# SAFETY REPORT CHANGE REQUEST – SECTION 2.5 DIABLO CANYON NUCLEAR POWER PLANT

DCPP Form 69-20108 (10/09/12)

Section(s): 2.5 (Seismology and Geology)

UFSAR Section 2.5 (Seismology and Geology) is revised to reflect the results of the Licensing Basis Verification Project review of the Seismology and Geology section and proposed enhancements. The proposed change is being processed against UFSAR Revision 20.

FSAR UPDATE
UNITS 1 AND 2
DIABLO CANYON SITE
FIGURE 2.8-33 FREE FIELD SPECTRUM HORIZONTAL 1991 LTSP (84TH PERCENTILE NON- EXCEEDANCE) AS MODIFIED PER SSER- 34

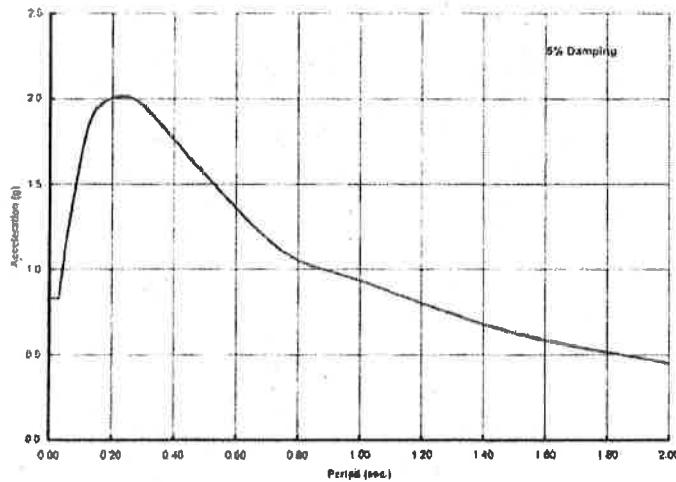
Added for Clarity – Refer to  
Applicability Determination Matrix Item  
# 36

36	N/A	N/A	2.5.33	N/A	Added Figure 2.5.33 Free Field Spectra Horizontal 1991 LTSP as Modified per SSER 34	N/A	SSER 34	N/A	N/A	N/A	LBVP Enhancement to add a figure in support of enhancements to the body of section 2.5.3.10.4.	N/A	This figure is based on Figure 2.4 SSER 34, Calculation 72.27 details the alteration from being a frequency based plot to a period based plot. This figure is used as support for material added in AD Matrix Item # 24. These enhancements are derived from correspondence with the NRC, NRC regulatory documentation, and specific UFSAR text; therefore, a 10 CFR 50.59 Screen is not required.	No
37	N/A	N/A	2.5.34	N/A	Added Figure 2.5.34 Free Field Spectra Vertical 1991 LTSP as Modified per SSER 34	N/A	SSER 34	N/A	N/A	N/A	LBVP Enhancement to add a figure in support of enhancements to the body of section 2.5.3.10.4.	N/A	This figure is based on Figure 2.5 SSER 34, Calculation 72.27 details the alteration from being a frequency based plot to a period based plot. This figure is used as support for material added in AD Matrix Item # 24. These enhancements are derived from correspondence with the NRC, NRC regulatory documentation, and specific UFSAR text; therefore, a 10 CFR 50.59 Screen is not required.	No

FSAR UPDATE
UNITS 1 AND 2
DIABLO CANYON SITE
FIGURE 2.5-34 FREE FIELD SPECTRUM VERTICAL 1991 LTSP (84TH PERCENTILE NON- EXCEEDANCE) AS MODIFIED PER SSER- 34

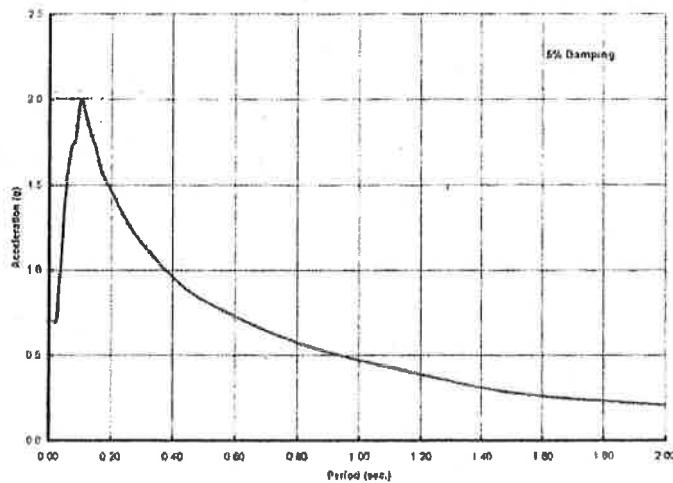
Added for Clarity – Refer to  
Applicability Determination Matrix Item  
# 37

FSAR UPDATE
UNITS 1 AND 2
DIABLO CANYON SITE
FIGURE 2-5-35
FREE FIELD SPECTRA
HORIZONTAL
LTSP (PG&E 1988)
GROUND MOTION
VS
HOSGRI (NEWMARK 1977)

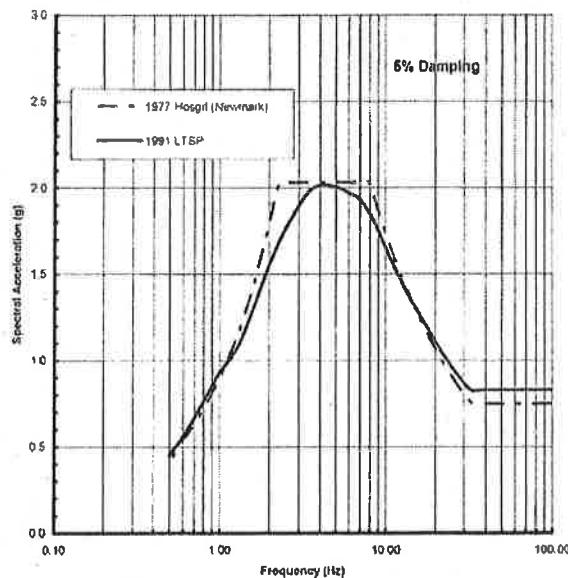
Added for Clarity – Refer to  
Applicability Determination Matrix Item  
# 38

38	N/A	N/A	2.5.35	N/A	Added Figure 2.5.35 Free Field Spectra - Horizontal LTSP (FCELE 1968) Ground Motion vs. Hoag (Newmark 1977)	N/A	N/A	N/A	N/A	N/A	LBVP Enhancement to add a figure in support of enhancements to the body of section 2.5.3.10.4.	N/A	This figure is based on Figure 7.2 of the Final Report of the Diablo Canyon Long Term Seismic Program, July 1988, updated as stated in SSER 34. This figure is used as support for material added in AD Matrix Item # 24. These enhancements are derived from correspondence with the NRC, NRC regulatory documentation, and specific UFSAR text; therefore, a 10 CFR 50.59 Screen is not required.	No
39	N/A	N/A	2.5.36	N/A	Added Figure 2.5.36 Map of Shoreline Fault Study Area	N/A	N/A	N/A	N/A	N/A	LBVP Enhancement to add a figure in support of enhancements to the body of section 2.5.7.1.	N/A	This figure is based on Figure 1-1 of the Report on the Analysis of the Shoreline Fault Zone - Central Coastal California, January 2011. This figure is used as support for material added in AD Matrix Item #29. These enhancements are derived from correspondence with the NRC, NRC regulatory documentation, and specific UFSAR text; therefore, a 10 CFR 50.59 Screen is not required.	No
